CUSTOMER ADVISORY

ADV2002

Label Content Update for FPGA and Power Products

Table 2: Label Sample with “RoHS COMPLIANT”

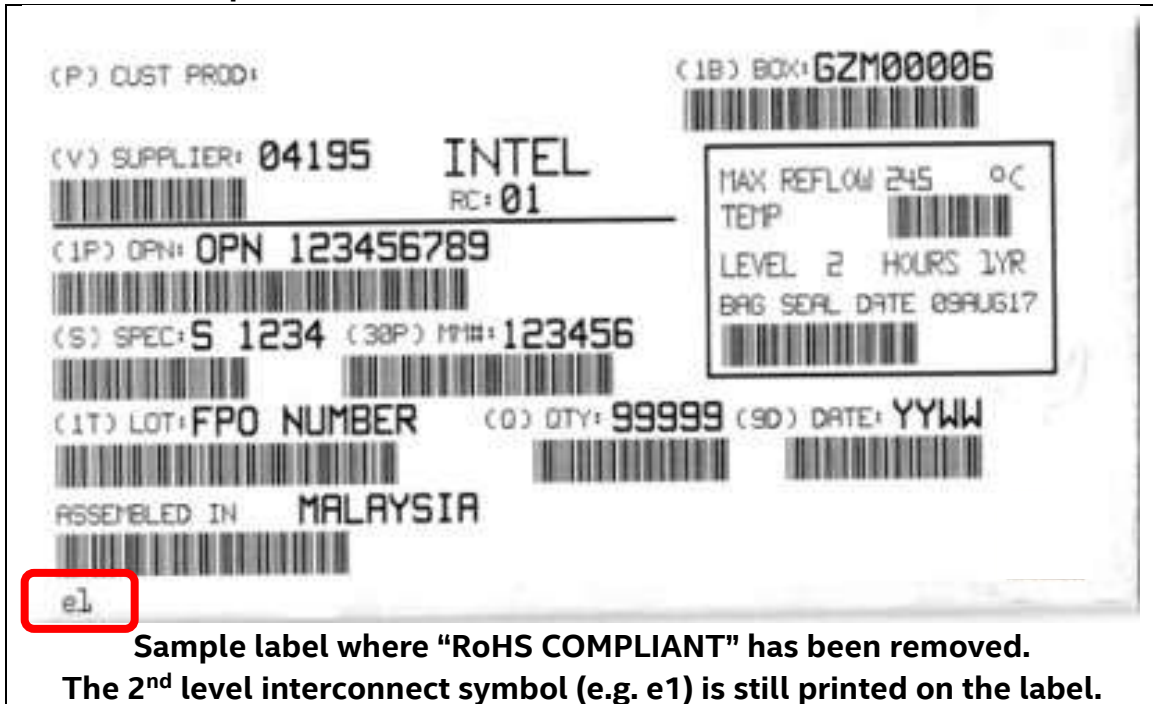
Change From	Change To
"RoHS COMPLIANT" indicated on the lower left of the barcode label	Labels may or may not indicate " RoHS COMPLIANT " on the barcode label. The 2nd level interconnect symbol (e.g. e1) remains printed on the label.
